Shearwater Peregrine Firmware v86 Release Notes

VERSION 86 2022-09-12

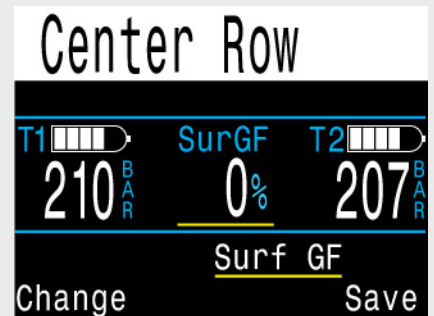
Previews of the tec center row display configuration have been added to make display setup easier.

Also, more options are available in the tec modes center position.

Surface GF is the gradient factor if you were to instantly ascend to the surface

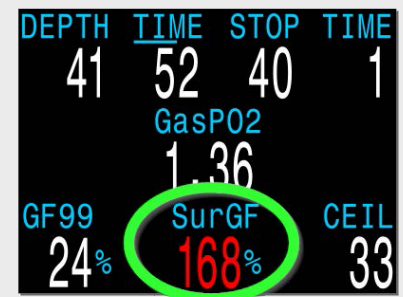
Surface GF display added. This shows the gradient factor if you were to surface immediately. This is different from GF99, which shows your gradient factor at the current depth. Is available:

Log Rate can be set to 2, 5, or 10 seconds

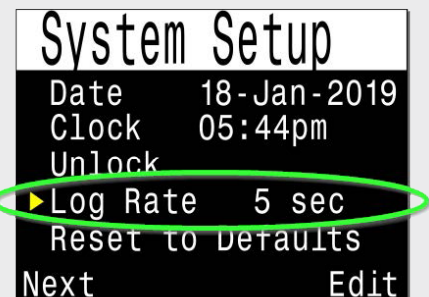
Log sampling rate can be set to 2, 5, or 10 seconds (previously always 10 seconds). Note that log downloads may take longer with faster sampling rates as more data is being recorded. Also, less logs can be stored until they are overwritten. For example, about 1000 hours are stored at a 10 second rate, but only 200 hours at a 2 second rate.

The “Clear Counter” counts up once deco is clear

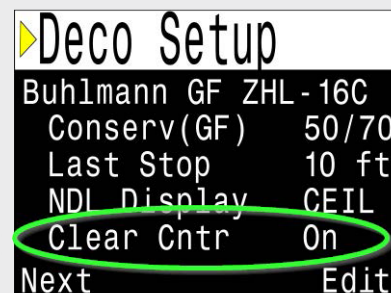
A “Deco Clear” up-counter option has been added.

When deco clears this counter begins counting up from 0. It is useful for timing additional padding after the mandatory decompression stops. If the dive did not need deco, then begins upon entering the safety stop zone (i.e. shallower than 20ft / 6m).

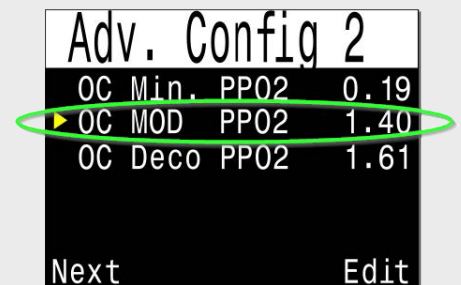
Previously, there was an “OC Max PPO2” setting which only defined when the “High PPO2” message occurred, regardless of dive phase (e.g. bottom depth or at deco stop). This confused many users who, quite reasonably, assumed it was the “bottom depth” limit and set it to 1.40. This would result in warnings during deco when the PPO2 was pushed to the 1.60 range.

The “OC Max PPO2” has now been removed and replaced with a “OC MOD PPO2” setting. The MOD setting only applies to the bottom depth phase. The dive computer automatically switches to using the “OC Deco PPO2” limit when within 2 stops of the next deco stop. The “OC Deco PPO2” limit also sets where predictive deco gas switches occur. Also, if the current gas has greater than or equal to 80% oxygen fraction, then the deco limit is used, as the gas is assumed to be a deco gas.

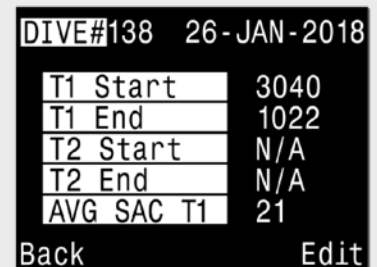
The in-computer dive log now displays start and end tank pressures and average SAC.

The mark heading command now requires less button presses

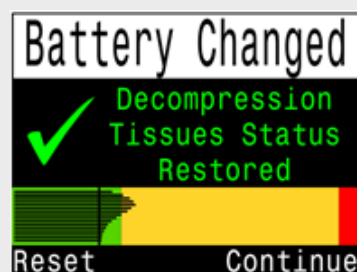
CHANGE Compass mark heading menu moved to reduce button presses. Also, the compass can now be viewed while marking. Operation: when viewing compass a left button press brings up an "Exit/Mark" menu. Right press marks compass, Left press exits to main screen. Previously had to navigate to regular menus to mark the compass.

The offset between current and marked heading is now shown (in this example 16°)

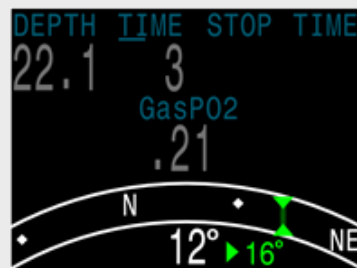
IMPROVE When a heading is marked, the display now shows the offset angle between the current heading and the marked heading. This is useful for navigating patterns. For example, a box pattern requires turns at 90° intervals, while a triangle pattern requires turns at 120° intervals.

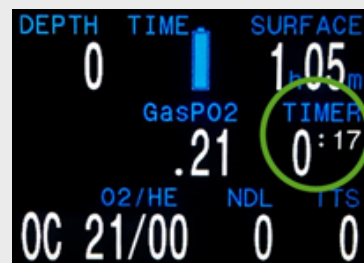
The current compass numerical value (azimuth) is shown on the “Mark Heading” menu.
